REGIONAL REVIEW NOTIFICATION

Name of Proposal: Westside Transfer Station Modification

Review Type: Development of Regional Impact

Preliminary Report:	May 26, 2006	DEVELOPMENT OF REGIONAL IMPACT REVIEW REPORT	Project:	Westside Transfer Station Modification #1125
Final Report Due:	June 25, 2006		Comments Due By:	June 8, 2006

SITE PLAN 1.0

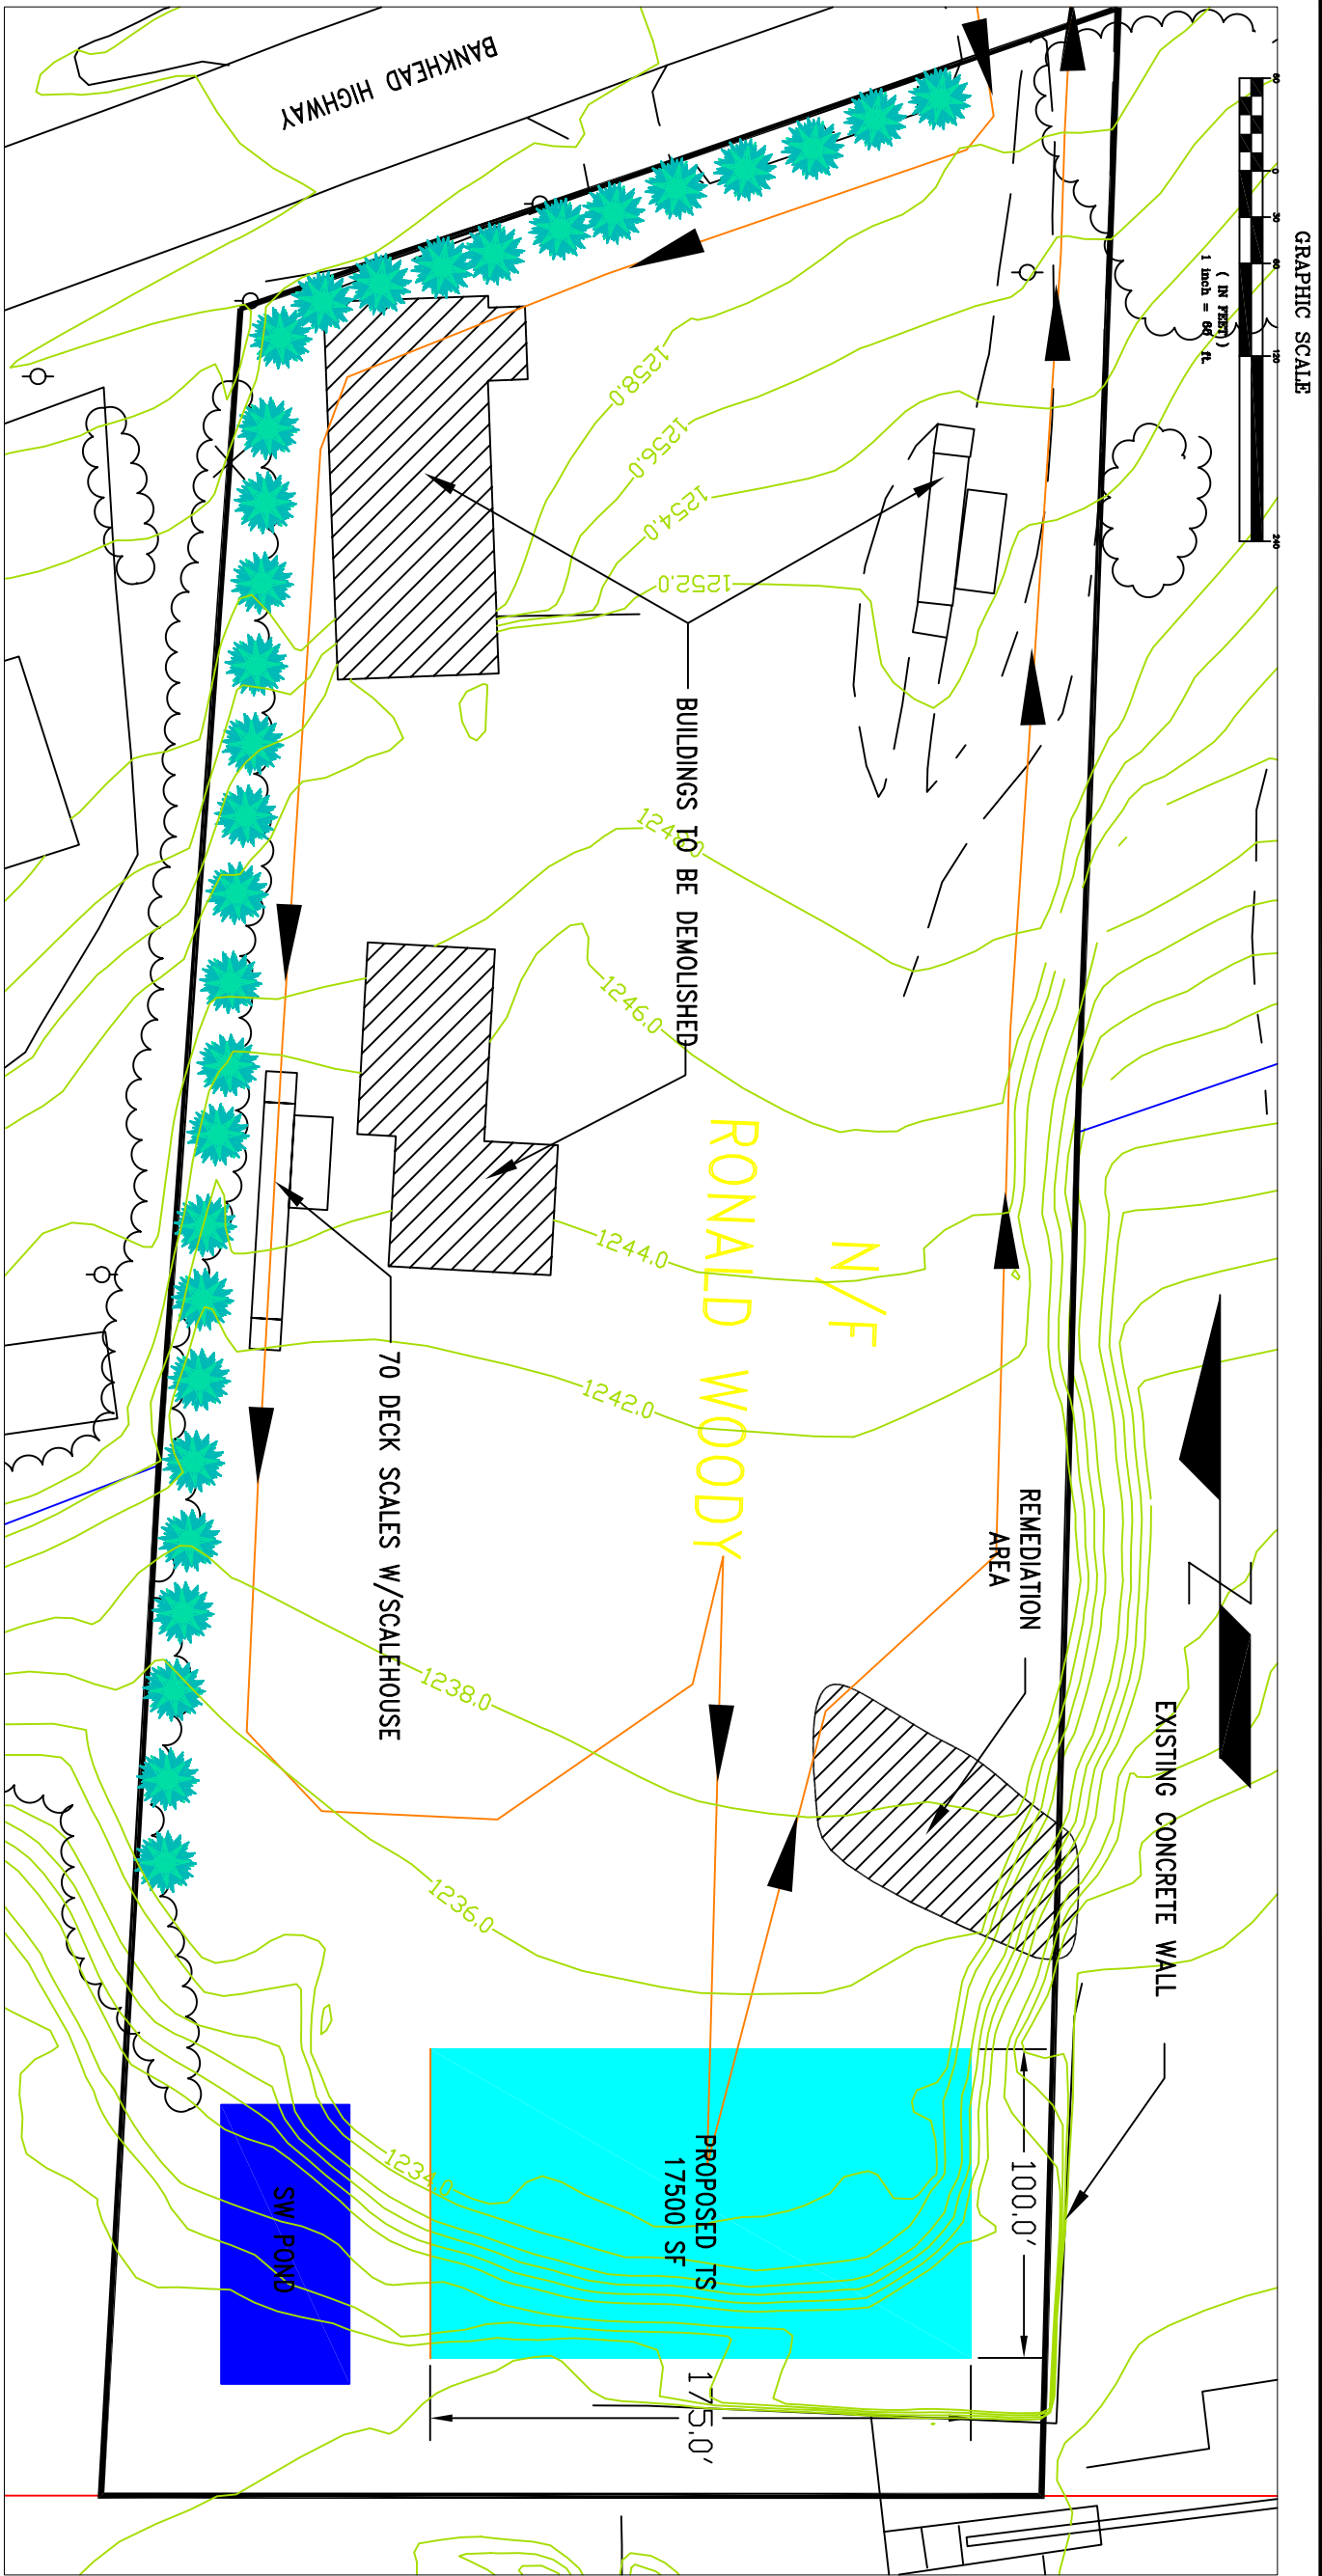
Shown on the site plan is an area along the eastern property boundary that requires 10 to 15 cubic yards of soil removal based on a previous use of the site as a lead recycling facility. The approved plan calls for onsite remediation during the summer of 2006.

4. Amy had asked about the status of the onsite soil remediation plan that has been approved by Georgia Department of Natural Resources after a quite lengthy permitting request of over 5 years. Shown on the attached site plan is an area located on the eastern property boundary that requires approximately 10 to 15 cubic yards of soil removal based on a previous owner's use of the site as a lead recycling facility. The case number is HIS #10256 labeled CR&A Battery Company. The date of the initial release was approximately 1989 based on our research through the permitting process. Copies of the site remediation plan are on file with both Ga DNR and Douglas County. The approved plan calls for the onsite remediation during the summer of 2006.
